Studebaker

SERVICE BULLETIN

NO. 259

1952

FIG. 1

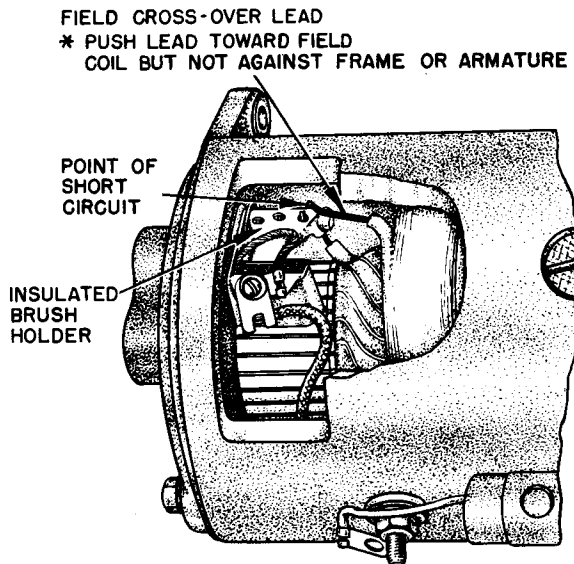
touching the insulated brush holder (see Fig. 1). This will create a short circuit, causing excessive field current. The result will be burned regulator contact points, high generator cut-in speed and failure of the generator to properly charge the battery. This will result in a "low" (discharged) battery.

It is believed the field crossover lead short circuit may have occurred only in some generators manufactured between June 1, 1951 and December 1, 1951. The production date can be determined from the figures above the word "serial" on the generator nameplate (see Fig. 2) as follows: Month code letter for January is "A", for February, "B", and so on through "H" for August. The letter "I" is not used, so that September is coded "J" and consecutive alphabet letters are used through "M" for December. The digit to the left of the code letter is the units digit for the year of manufacture: "1" for 1951, "0" for 1950, etc. The digit to the right of the code letter is the day of the month of manufacture, these digits running from 1 through 31.

If crossover lead touches (or nearly touches) the insulated brush holder (as in Fig. 1), push the lead back toward the field coils but not against the generator frame or armature. This will prevent future short circuits by the crossover lead.

FIG. 3

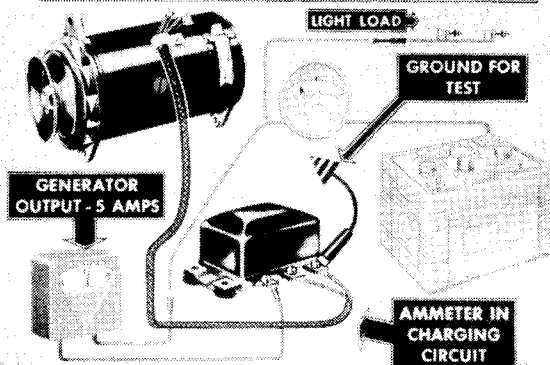
Insert an ammeter at "BAT" terminal of the regulator (see Fig. 3). Turn on the headlights. Run the engine at a speed that will give approximately 5 amperes output (positive charge) as shown on the test meter. Ground the "F" terminal of the regulator as shown in Fig. 3. If the output increases more than 2 amperes, the regulator should be removed from the vehicle and cleaned and adjusted as outlined in the Electrical section of the 1951 Passenger Car Shop Manual. Set voltage regulator to 7.6 volts at 70° F. and set current regulator at 40 amperes at 70° F. Dealers may, if they so prefer, take such regulators to United Motors Service, who will repair or replace the unit at no charge to the Studebaker dealer.

NOTE.--Discoloration of points does not necessarily indicate serious point damage. Cleaning should be attempted unless point material is badly burned. Replace the entire regulator only when points cannot be put in serviceable condition by cleaning.

FIG. 4

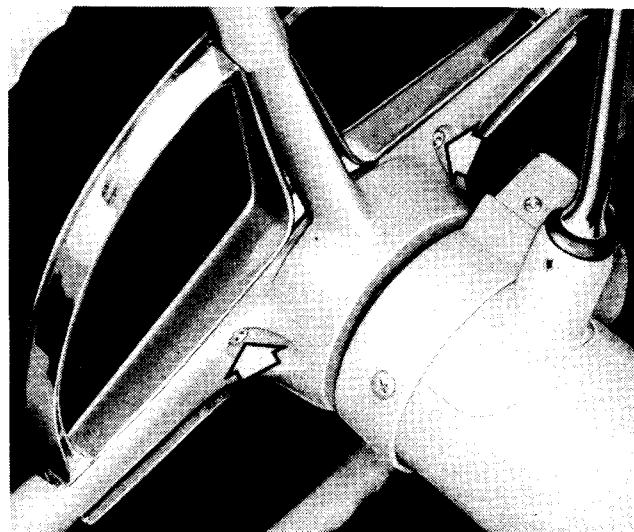
There is a difference in the mounting of the horn half-ring on 1952 Champion (12G) and Commander (3H) models from that used on prior models. The ring is held to the steering wheel by means of two Allen-head screws (see Fig. 4).

To remove the horn half-ring, remove the two Allen-head screws holding the ring assembly to the steering wheel and remove the insulating collars. Lift the bottom of the ring enough to clear the steering wheel spokes and slip it forward, unhooking it from the contact plate. Lift the ring and rubber cushion from the wheel. The contact plate can now be removed.

To install the horn half-ring, place the rubber cushion in position in the ring. Hook the ring to the contact plate and lower it into position. Install the insulating collars on the Allen-head screws, and insert the screws and insulators through the steering wheel spokes. Tighten the screws.

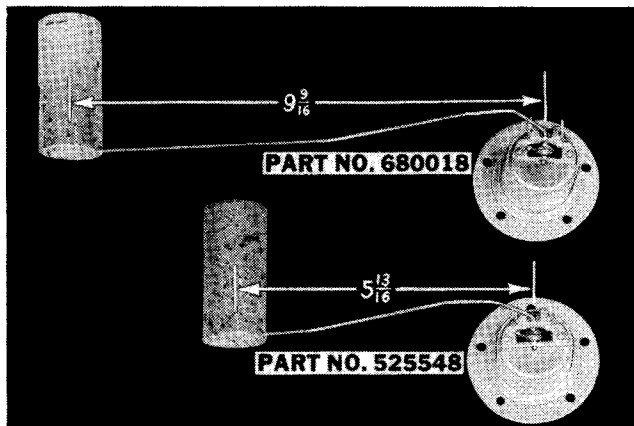
The brake master cylinder spring-loaded (residual pressure) valve has been changed to a dome type with a rubber valve in place of the flat valve formerly used on the truck models listed above. See the drawing for a comparison of the design details of the two

valves. The valve shown on the left is the spring-loaded flat type formerly used, while that on the right is the dome type with the rubber valve. The small drawing at upper right is an enlargement of the dome type valve to show details.

The dome type valve is sold by Studebaker parts depots in a kit, Part No. 681011, Brake Master Cylinder Valve and Seat Kit which includes Part No. 681009, Valve, and Part No. 681010, Valve Seat. The dome type valve parts entered production approximately December 18, 1951.

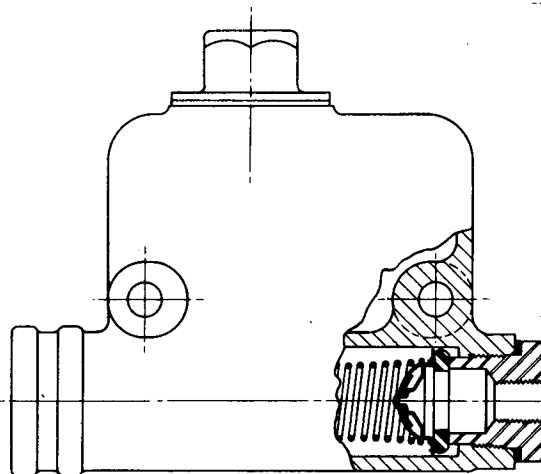
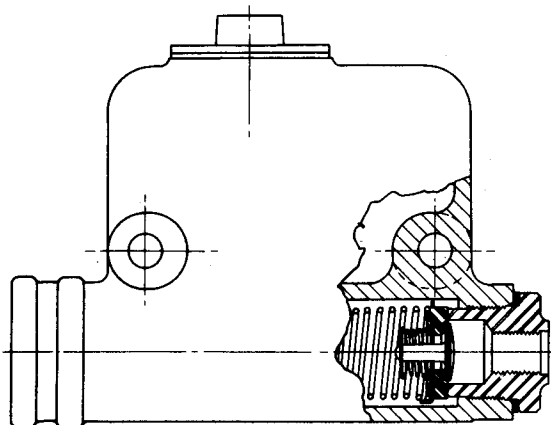
In a few cases the gasoline gage tank units for service have been packaged under an incorrect part number. The illustration above shows the correct part number and application for each of the two styles of gage.

The long arm (9-9/16") unit, Part No. 680018,

should be used on 2R Series trucks. The short arm (5-13/16"), Part No. 525548, is for use on passenger car models.
